CPRE PDSY REBUTTAL OF REP8-018 - NH'S REBUTTAL OF REP7-036, REP7-034, REP7-035

REP7-036 Keith Buchan Response to REP6-017 and comments on Examining Authority's Second Written Questions (WQ2)		
Ref	NH comments	CPRE Response
9.74.1	(iii) No further BCR calculations until detailed design & economic assessment in Dec 2022	<p>The calculations NH now criticise were submitted to deadline 4 [REP4-016 page 6 onwards] and reproduce some of NH's numbers. The assumptions were made clear: i.e. a low and high growth scenario with high and low carbon values. Their new calculations do not agree with this table and no detail is given for them. This issue should have been raised earlier and is another example of the lack of technical dialogue resulting from NH's refusal to allow direct contact between professionals on this subject. We have many outstanding clarificatory request. Meanwhile we attach the worksheet on which the CPRE calculations are based (see accompanying Technical Note comparing the scheme's BCR with old and new values for carbon) It can be seen that it replicates the central forecast correctly, so it is hard to see why NH's figures differ from ours. Transparency on calculations suc

Figure V2: "Right Mix Vision" change in volume of trips by mode for 'Now' and '2040', by spatial theme

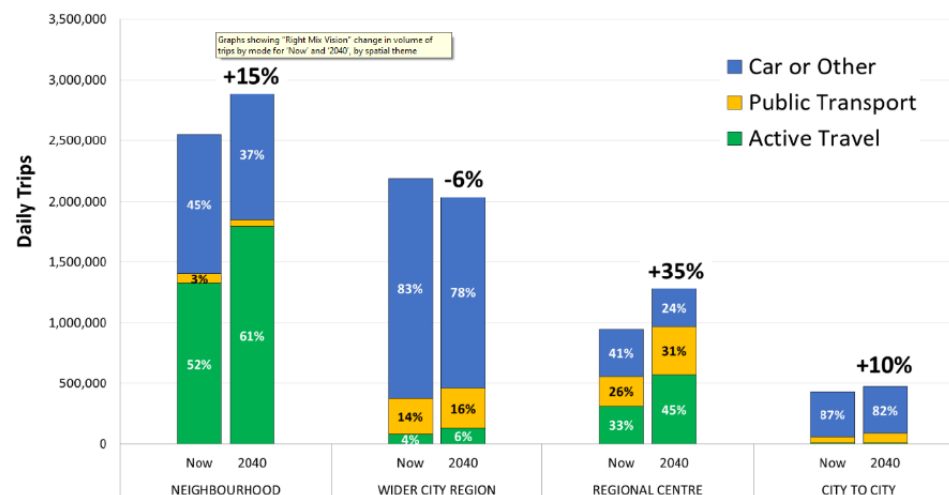
<p><i>must respond flexibly to changes that arise over time</i>'. In planning a transport intervention of this size it is essential that the implementation of other interventions are included in its assessment. The NH argument appears to be that because of the scheme's timing such changes can be ignored. A relevant question might be, do NH accept that future schemes will have to follow the procedures we have called for? Our view is that they clearly would.</p>
	<p>Q3.3.NH does not address the full Right Mix policy – only the 5% reduction City to City car trips – or the urban location of the scheme No response to suggestion to adjust growth factors and matrices and run an option without road scheme</p>	<p>The Right Mix Strategy, which is being reviewed in light of new Government targets and the Pandemic, has been used by CPRE to inform the assessment of the CPRE alternative package. It is a good example of a variable demand forecast used to test alternative options that NH consider “unconventional”.</p> <p>Although offered in rebuttal, the NH response seems to confirm our view, that the vast majority of car trips in the model will be subject to demand reduction, not just through slower growth but in absolute terms. This has been the subject of previous submissions by CPRE, referring to the Right Mix Strategy.</p> <p>While it reproduces a relevant part of the Right Mix vision, NH's answer seems to imply that City to City trips are the most important for this scheme. However these trips are a very small percentage of the traffic forecast. We have undertaken a further calculation from the NH matrix data to confirm this point.</p> <p>If the total trips originating in the local area (Sector 1) and travelling to all 25 sectors covering the whole of Britain are the baseline, 94% of those trips go to immediately adjacent sectors. Excluding the rural Sector 7 from this produces 93%. All of these trips are therefore relatively short distance (relevant for non-rail mode switch) and in areas directly affected by the Right Mix policies.</p> <p>For convenience CPRE also reproduces the Right Mix chart. This shows a decrease in car trips of 6% for local neighbourhood journeys, 12% for the wider city region and 21% for trips connected to the regional centre. These are precisely the categories which form the vast majority of the trips most relevant to this scheme.</p>

NH have simply ignored the impact of these policies on their traffic forecasts. It should also be noted that no trip length distribution for the Mottram link has been supplied to back up the NH rebuttal. However, the matrix analyses undertaken by CPRE using NH data both the new one above and already submitted to the DCO show its importance.
